Proposal: Conversion of existing integral garage to habitable space & erection of detached garage & seating enclosure.

Site: Willows Hoe Lane, Flansham, PO22 8NT.

Y/31/18/HH

Southern Water MapGuide Browser

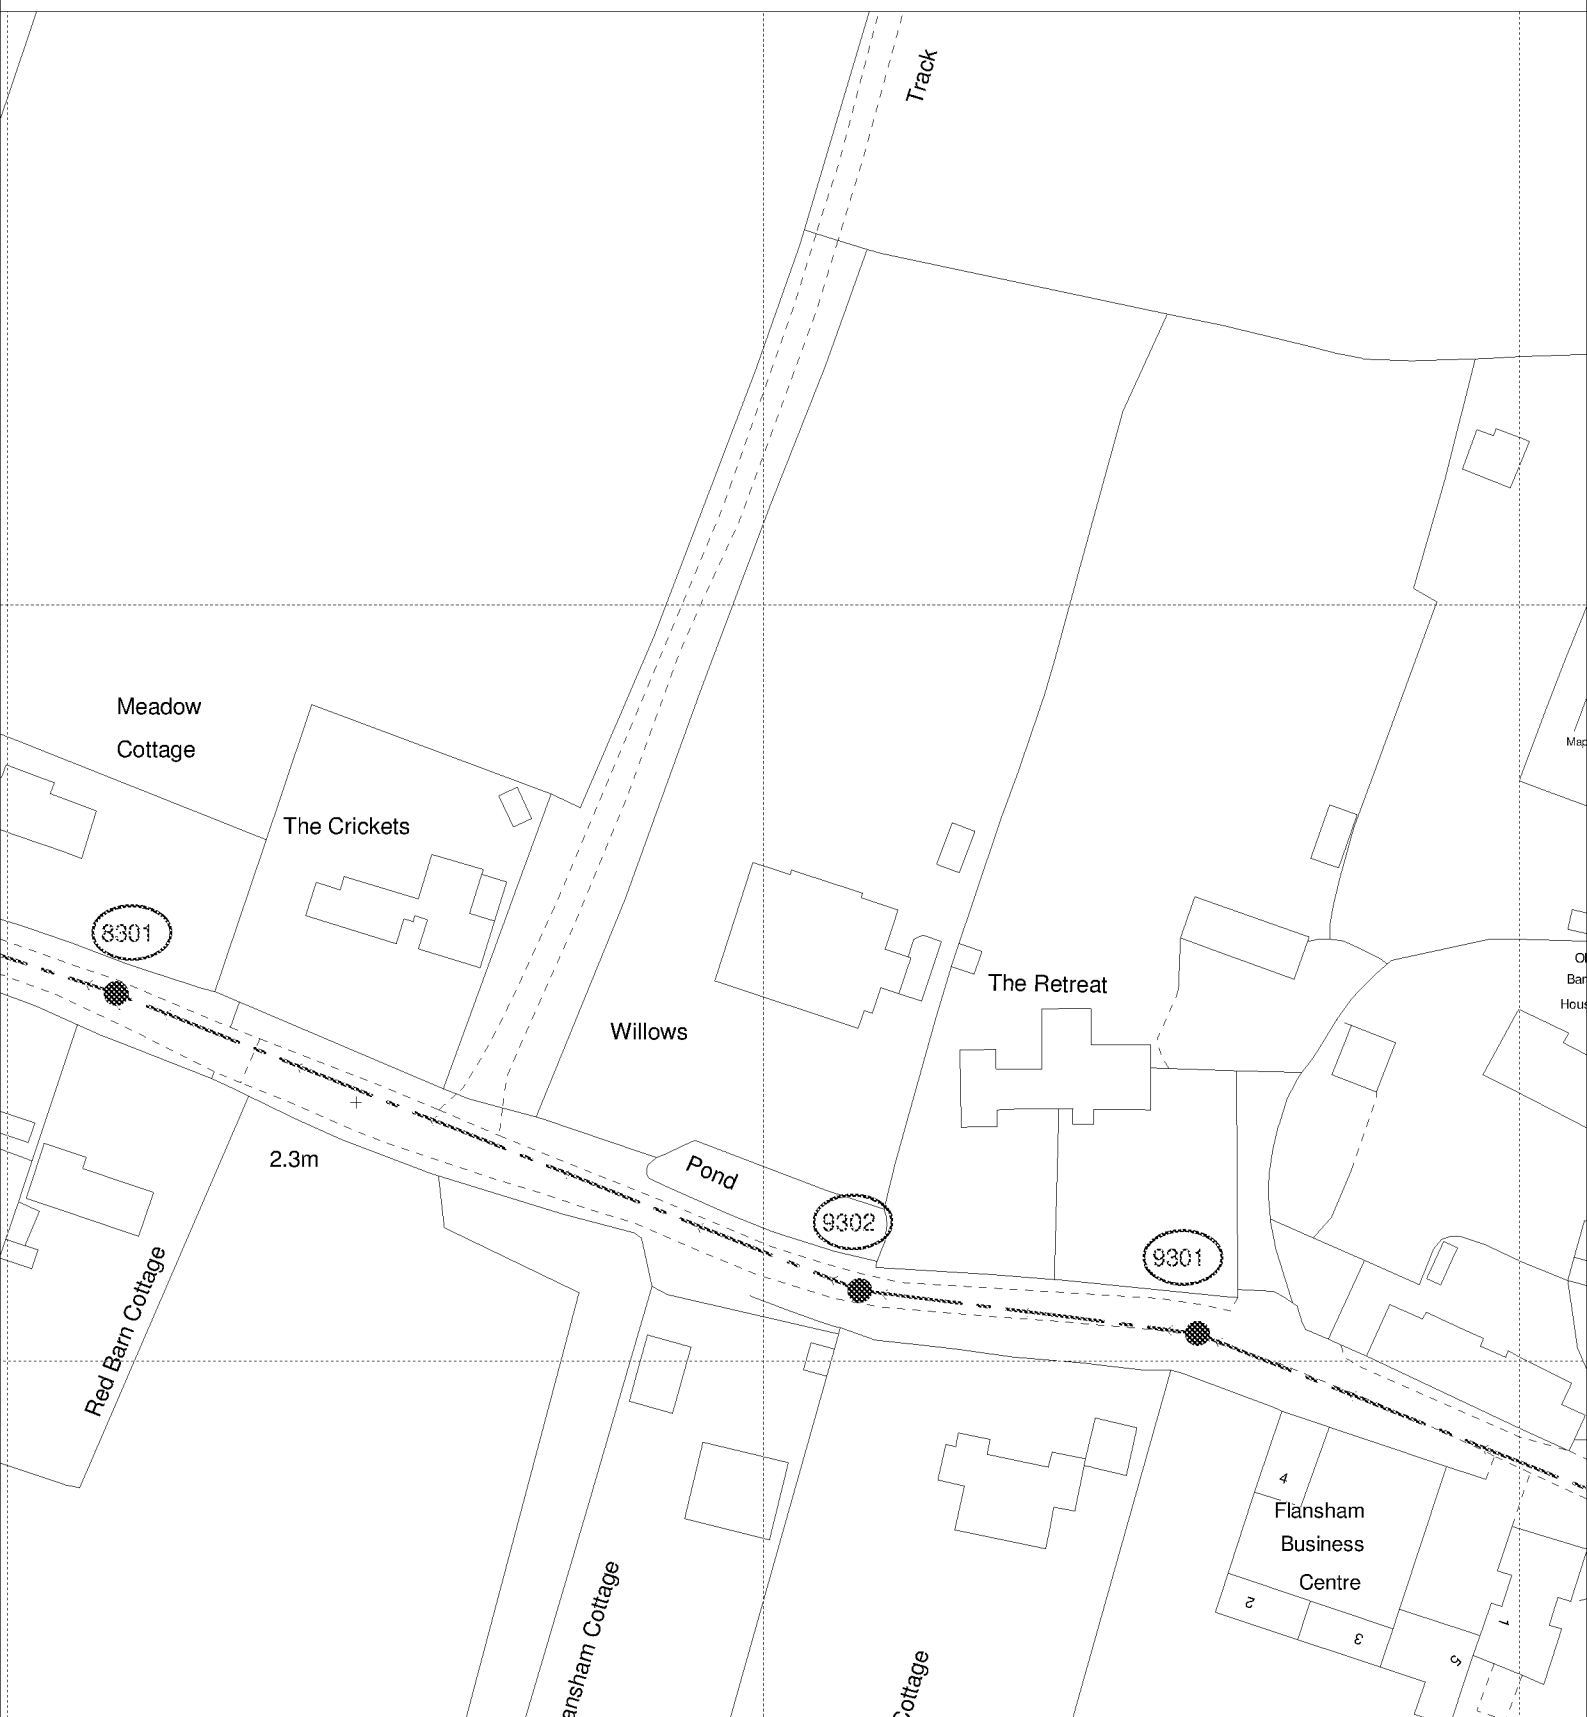
Our initial investigations indicate that there are no public surface water sewers in the area to serve this development. Alternative means of draining surface water from this development are required. This should not involve disposal to a public foul sewer.

Due to changes in legislation that came in to force on 1st October 2011 regarding the future ownership of sewers it is possible that a sewer now deemed to be public could be crossing the above property. Therefore, should any sewer be found during construction works, an investigation of the sewer will be required to ascertain its condition, the number of properties served, and potential means of access before any further works commence on site.

Due to surface water inundation issues in the Lidsey Catchment "The applicant is advised to adopt, where appropriate, the measures in the table "Practical measures to reduce the potential impacts of development".

Developer should look to protect the public sewerage system from inundation and infiltration, which contribute to flooding in unfavourable conditions.
